Re: PER Drainage design review

Subject: PER Drainage design review

EA has reviewed the latest drainage design and calculations for the PER property sent to EA on October 22. EA concurs with the submitted calculations and approach to manage the 100-year runoff from the 3975 Elm Avenue property. However, the pre- versus post-development ponding conditions have still not been quantified along the 3975 Elm Avenue/PER property line to show improvements to drainage conditions (see #4 below). The storm drain plan view layout has not changed since the last submittal but the storm drain pipe sizes have been increased and the pipe inverts have generally been lowered to decrease the water surface elevations in the system during the 100-year rainfall event. Additionally, a TideFlex valve has been added to the outfall of the storm drain system which conveys water from the 3975 Elm Avenue property. The following are EA comments provided to you on October 2 (in black) followed by EA's observations of the revised October 22 submission in red:

POST DEVELOPMENT CALCULATIONS FOR BOUNDARY DITCH

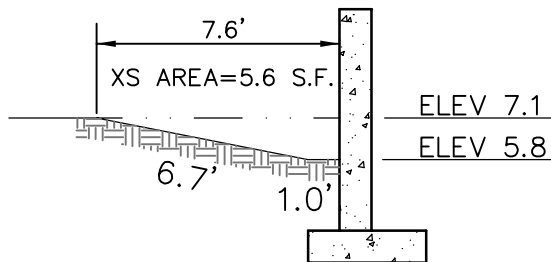
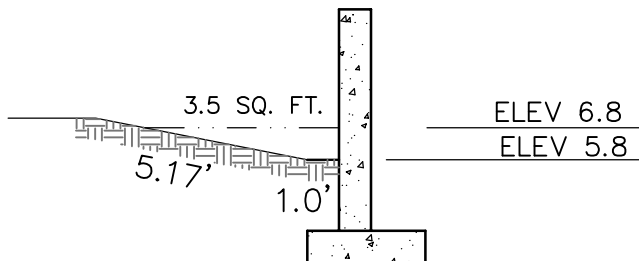
4. Pete met with Mr. (b) (6) on 9/24 to discuss drainage patterns of the 3975 Elm Avenue property. Attached is an annotated C2 sheet indicating the drainage patterns on the property as described by Mr. (b) (6) and as confirmed during the visit. EA strongly suggests using similar drainage area delineations to the attached annotations to demonstrate to Mr. (b) (6) that his concerns have been addressed. Also, Mr. (b) (6) is very concerned about the capacity of the ditch between the PER property and his, and he is also very concerned about maintaining positive drainage from this area in the pipe along the swale alignment you are proposing. EA strongly suggests that you perform a pre-development conditions analysis to demonstrate that the proposed PER development will improve the drainage along the PER/3975 Elm Avenue property boundary in the post-development condition. This could be demonstrated through improved water surface elevations and lack of ponding in the ditch between the two properties.

END SECTION AT STMH-1 TAKES IN 1.93 ACRES FROM THE DIXON TRACT PIPE OUTFALLING AT THAT LOCATION. 1.93 ACRES WILL NO LONGER FLOW THROUGH THE DITCH, BUT WILL BE INTERCEPTED BY THE NEW PER STORM DRAIN AT STMH-1

THE 100 YEAR STORM ON A PRE DEVELOPED CONDITION IS NOT CONTAINED IN THE EX. DITCH SECTION AND WILL REACH A MIN. ELEVATION OF 7.1 (TOP OF DITCH BANK); SINCE WATER IS REMOVED FROM THE DITCH VIA ONSITE GRADING AND WITH THE ADDITION OF A FES AT STMH-1, THE WATER SURFACE PROFILE ELEVATION IS LOWER AT POST DEVELOPED CONDITIONS.
